ADDENDUM NUMBER 2

Project Number: **STP 3400 (439)**

Project Title: **Minor Park Connector Trail**

ISSUE DATE: **November 7, 2014**

CONCRETE TRAIL MARKER ~ 3/4"=1'-0" ~ 000-00-0.dwg
 BLUE RIVER AND INDIAN CREEK TRAILS

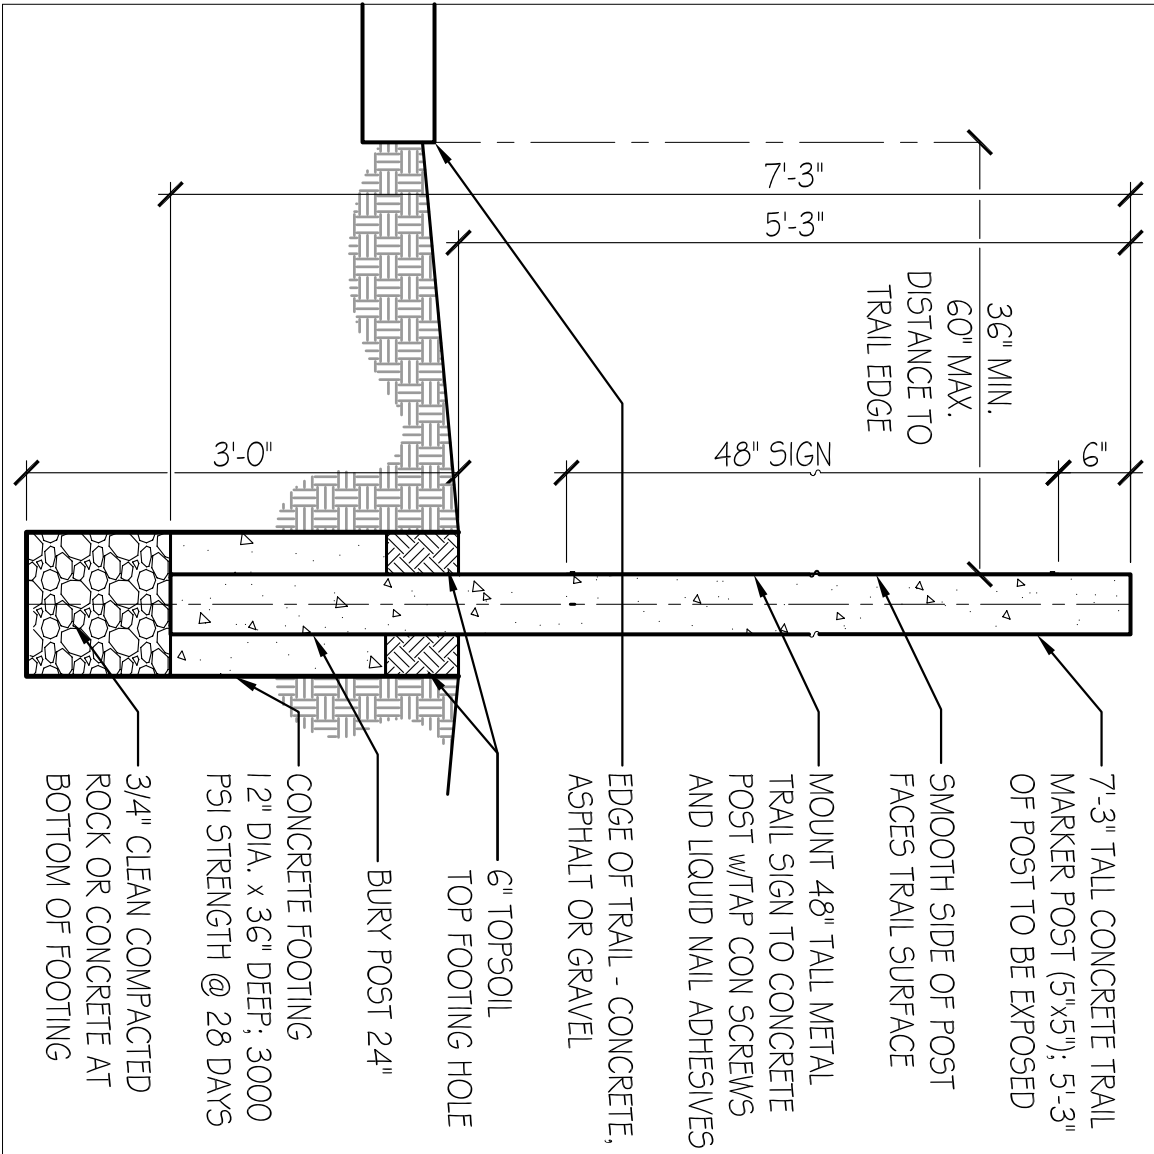
Q1. The plans call for the trail markers to be stone and to match the existing size of the Blue River markers; the plans also show the markers being 8" x 8". The existing markers appear to be colored concrete made to look like wood. The size of the existing markers is 5 1/2" x 5 1/2".

Answer 1-Bid 5 1/2" x 5 1/2" concrete post and installation. Sign is provided by other. Specification is attached to Addendum #2.
